FINAL COMMENTS AND RECOMMENDATIONS
MRGO Ecosystem Restoration Draft Feasibility Report (DFR)
3-4-2011

The following stakeholders submit these recommendations and comments to the Army Corps of Engineers in reference to the Mississippi River Gulf Outlet Ecosystem Restoration Plan Draft Feasibility Report:

Ten Pontchartrain Coastal Lines of Defense Project Areas. 1, 2, 3, 4, and 5 have some restoration proposed in the TSP, while 6 & 7 should be added.

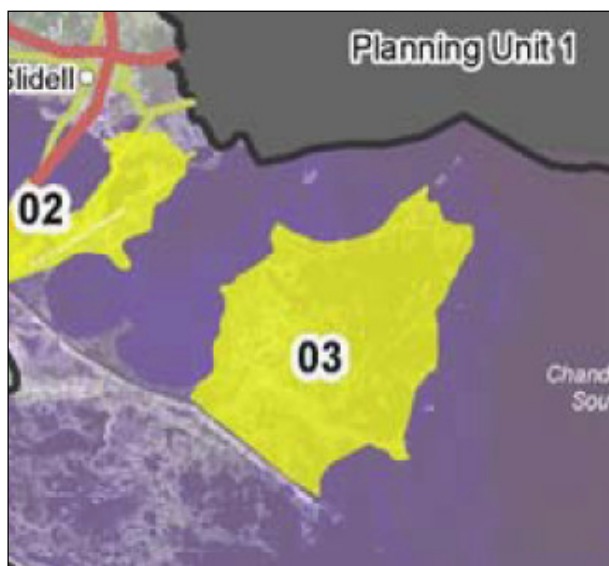
1) The two Biloxi Marsh land bridges, which are outside the levee system and part of a “Critical Landscape Feature” (6&7, see detailed comments below), must be added because of their exceptional relevance to the area of impact and critical importance to restoration and flood protection. In addition, a more significant restoration of the Bayou la Loutre ridge (2) is strongly

2) A more extensive bottomland hardwood restoration of Bayou la Loutre should be included. In lieu of a “Wetland Value Assessment”, “Habitat Suitability Indexes” for appropriate forest species (gray squirrel, white tail deer, etc) should be used for metrics to guide the design and performance of this restoration type.

Approximate location of TSP restoration polygons – note that several polygons appear to fill over exiting wetlands. These areas should be evaluated before filling. (Yellow outlines are swamp restoration to elevation +4.5 ft. Orange outlines are swamp nourishment areas with lower final elevation.)

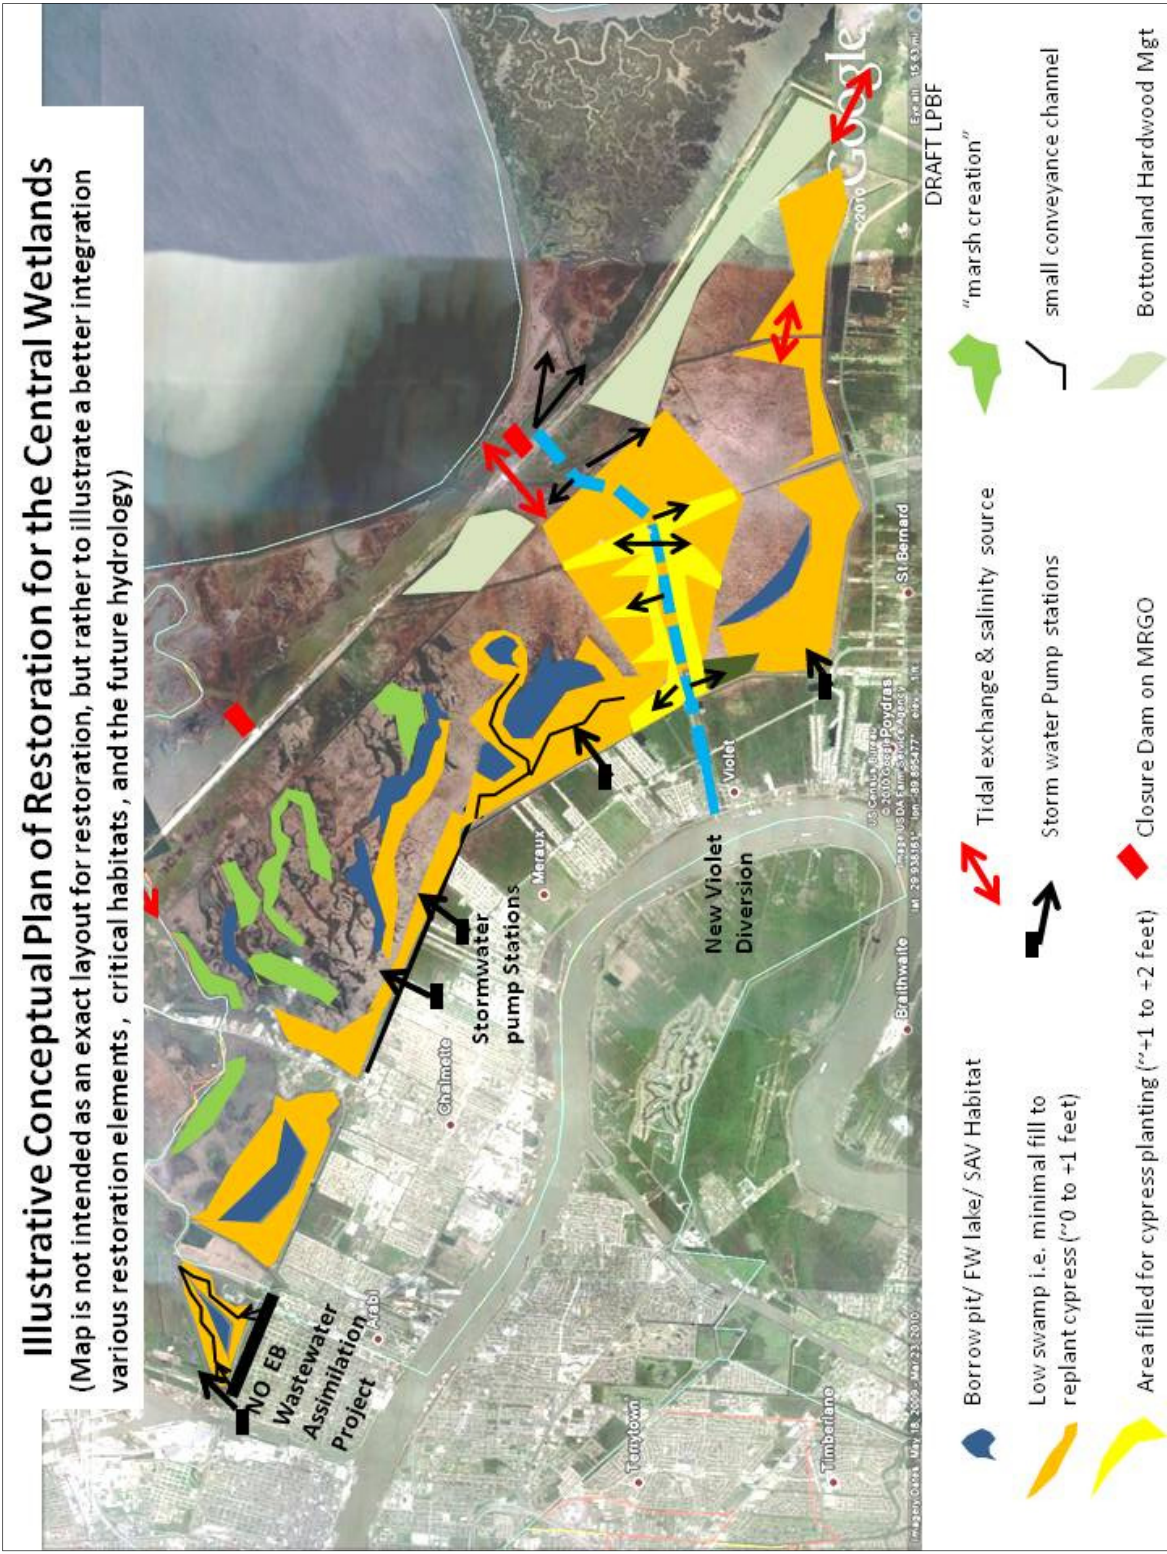
One disturbing aspect of the TSP is that some areas of proposed swamp restoration and swamp nourishment are actually where there is marsh already present (see map below). However, the majority of the marsh is in poor shape and seems to be in the process of conversion to open water. The TSP proposal of large scale filling of marsh to create swamp habitat is an unproven approach that should be implemented gradually with close scrutiny of its effects before the approach is used throughout the Central Wetlands. In any event, some restoration will have to take place on the marshes or they will convert to open water. The proposed swamp restoration elevation is +4.5 feet, which would place 3-4 feet of fill over existing marsh in some places. We are concerned that this filling of a wetland may require further mitigation for impact to the existing wetlands. This “snowball effect” that could be created as existing wetlands are destroyed and new mitigation is undertaken would be counterproductive to the goal of the project, could introduce greater uncertainties about its outcomes, and is likely to increase the costs of the project above the already high costs estimated for the TSP. However, it must again be noted that much of the marsh is in the process of converting to open water, so this must be taken into consideration in making restoration decisions.

3. Locate swamp restoration and nourishment primarily in areas of open water or very thin marsh to minimize impacts to emergent marsh already present.
4. Evaluate the source of sediment and the use of a sediment trap along the St. Bernard reach of the Mississippi River. Use of sediment from Lake Borgne for swamp projects will delay benefits since leaching of salt will require a few years and delay planting of cypress. (A sediment trap is a dredge hole on the Mississippi River bottom which will capture future bed load sediment in the river, allowing future use of the sediment for coastal restoration.) Use of a sediment trap in the river for the Central Wetlands restoration would reduce the distance to pump sediments by more than 50%. In addition, sediment mined from the river will have

Bathymetry of Lake Borgne/Breton Sound study area. Preferred mining locations will be along the -12 foot contour on west side of Breton Sound (Gautier et al. 2008)

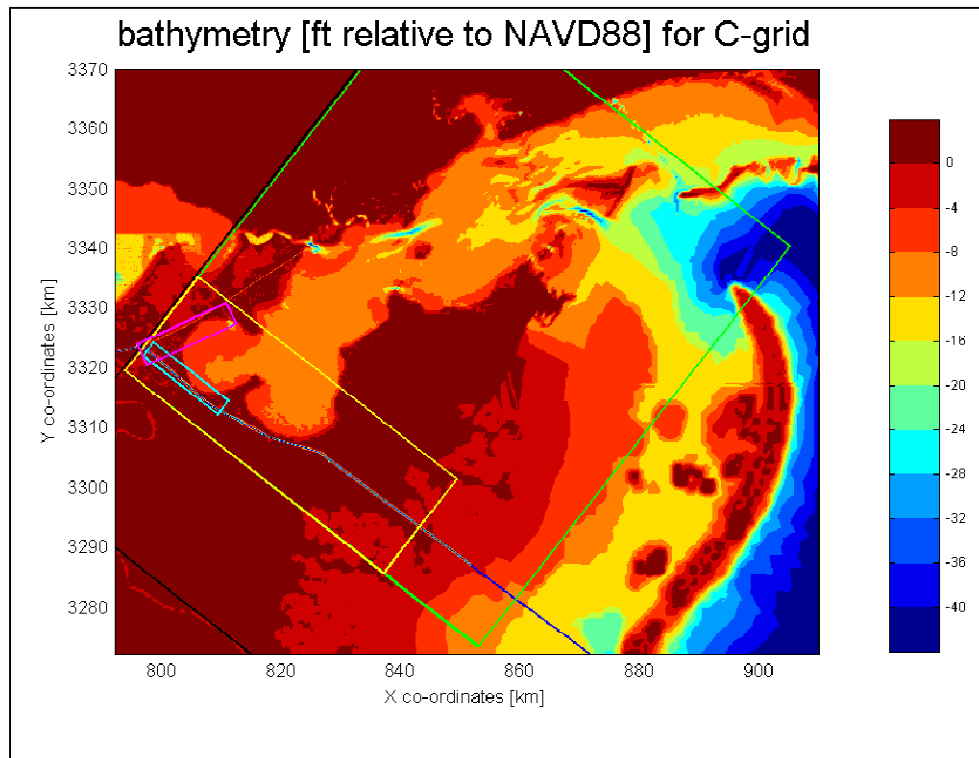
The deeper areas of Breton Sound are known to refill rapidly, and will contain more shell and sand than will be found in Lake Borgne mud. Remember, this is the area where the MRGO channel had to be re-dredged every time a tropical system passed, due to sediment infilling the channel. The reason that Breton Sound is a better borrow source is that it can be mined in a more sustainable manner along the -12 foot contour where wave action is greater causing more lateral sediment movement (figure below). It's also possible that dredge pipe could be conveniently deployed up the MRGO channel from the sound to proximate areas of restoration.

1. Use less stringent design elevation requirements to lower cost;
2. Evaluate Mississippi River including use of a sediment trap;
3. Evaluate adjacent sounds as borrow sites including Breton, Chandeleur and Mississippi Sounds;
4. Create freshwater lakes in the Central Wetlands using sites for borrow material;
5. Evaluate section of the MRGO spoil bank inside the Central Wetlands as potential borrow material.

FIGURE 1. Section Downstream of Culvert – 7,000 cfs.

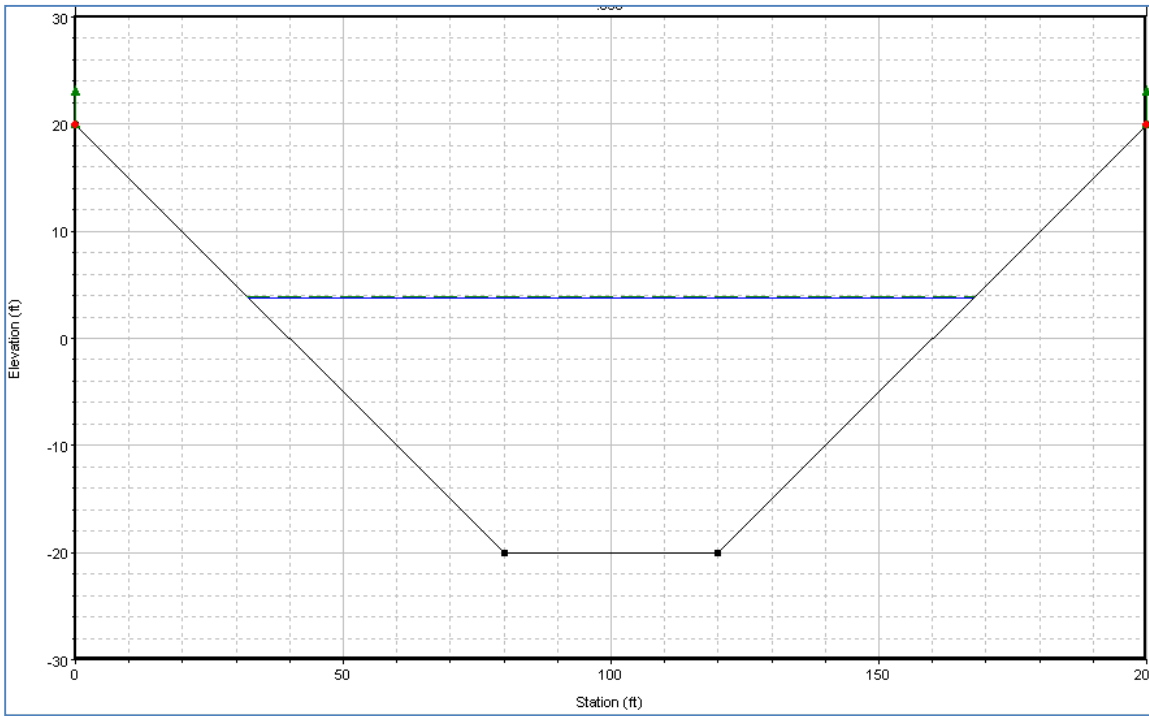
A preliminary analysis of the existing Violet canal indicates that with modifications, it can be used to convey the 7,000 cfs, when using the current boundary conditions (i.e. exceedance criteria). Dredging would be required to between Elev. -20 and -21 throughout the canal length compared to -12 in the TSP. The geometry used in this analysis consisted of a bottom width of 40 ft. and 3:1 side slopes. At 7,000 cfs., the top width and stage at the upstream end of the channel would be 135ft. (the approximate current width of the channel) and Elev. 3.8 ft., respectively. With 1 ft. of freeboard, the top width of the channel would be 140 ft, the cross-section just downstream of the Mississippi River culvert (when the flow is fully expanded) is shown in Figure 1 (ignore the extra cross sectional area above the water profile). The profile of the channel during this scenario is depicted in Figure 2.

FIGURE 3. Section Downstream of Culvert – Theoretical Maximum Flow

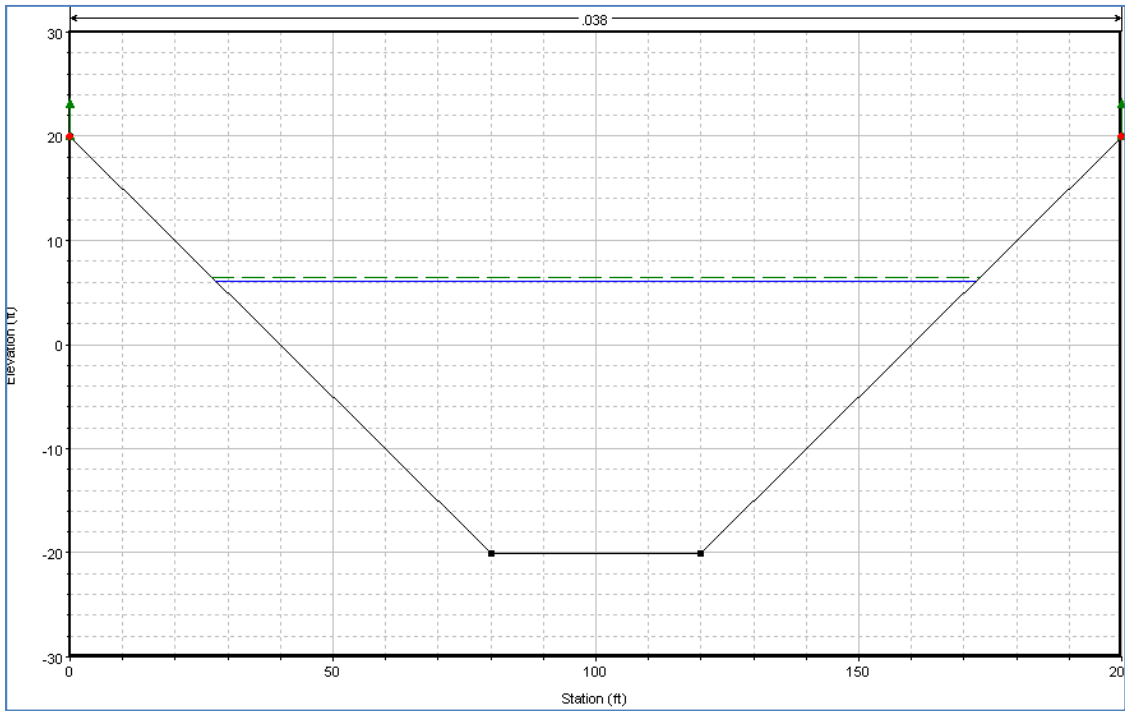
For this same channel geometry, the 99% non-exceedance stage at the River (Elev. 12.3 NAVD), the same stage at Lake Borgne as in the original analysis, and assuming that the sluice gates at the culvert are left wide open; the stage at the above-mentioned cross section would be at Elev. 6.1, the top width at 230 ft., and the diversion would flow at approx. 10,393 cfs. The same cross section with this scenario is depicted in Figure 3. Of course, allowing flows greater than 7,000 cfs is not part of the current TSP.

FIGURE 4. Plan View showing local levees

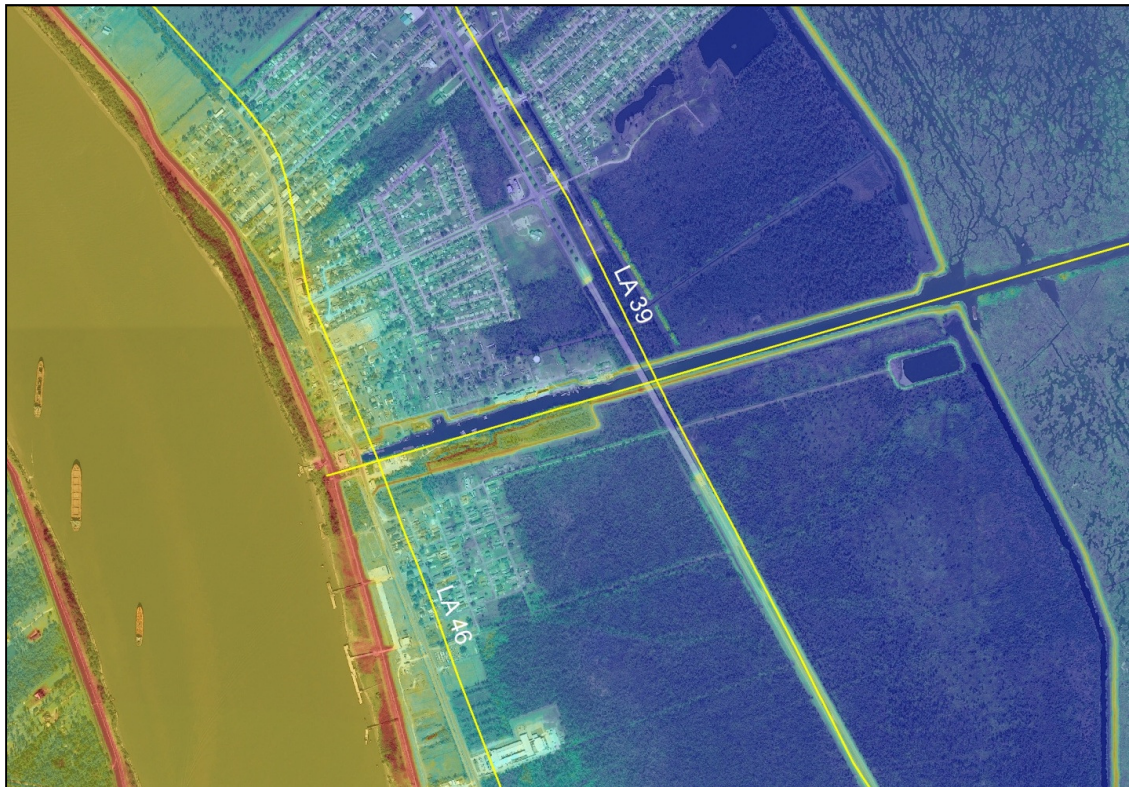
The 40-Arpent Levee culvert structure included in the TSP appears unnecessary for a diversion at Location 3, as was noted above. Referencing Fig. 4 (note the ridges in the LIDAR), removing the culvert could be done in the TSP from a hydraulic standpoint, but this might engender more concern for hurricane protection by appearing to allow surge to intrude into canals that traverse populated areas. Of course, no provision exists in the TSP to close this opening in the 40 Arpent Levee so that is not relevant. The USACE does not believe it is authorized to beef up storm protection, so H&H doesn't see the need to put a gate here, because one isn't there now. The current levees could simply be enhanced to handle the diversion, in which stages are not extremely high.

FIGURES 5 and 6. Comparison of diversion flowline at 7,000 cfs at TSP location (above) and simpler existing Violet Canal deepened to 20 ft. (below).

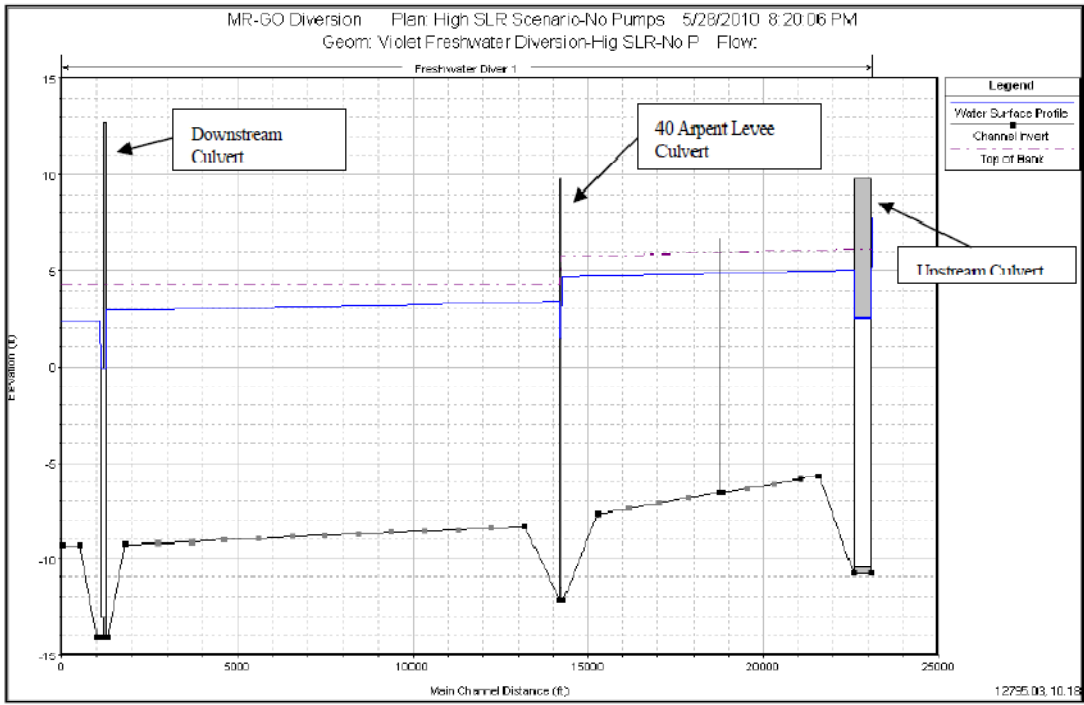
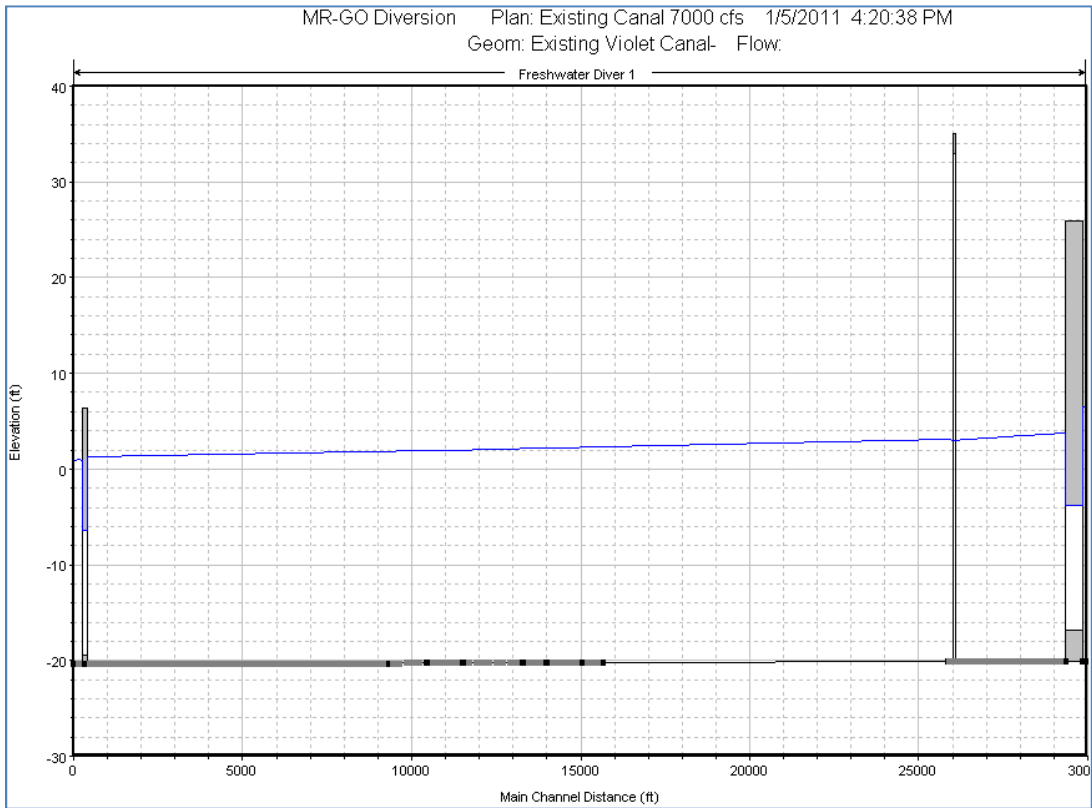
as a divide in the forced drainage plan. The Engineering Appendix does not provide a cogent basis for the shift. It appears from the initial work that any of the channels serve as well as another from the hydraulic standpoint. Clearly, the costs should be lower for the existing channel (Location 3), particularly as we concur with USACE H&H personnel that the footprint (top width) of all channel alternatives has been greatly overestimated (see next section). This appears to be a holdover of the original specifications for a larger channel (p. 2-73) capable of conveying twice the maximum discharge (15,000 cfs) now envisioned (7,000 cfs).
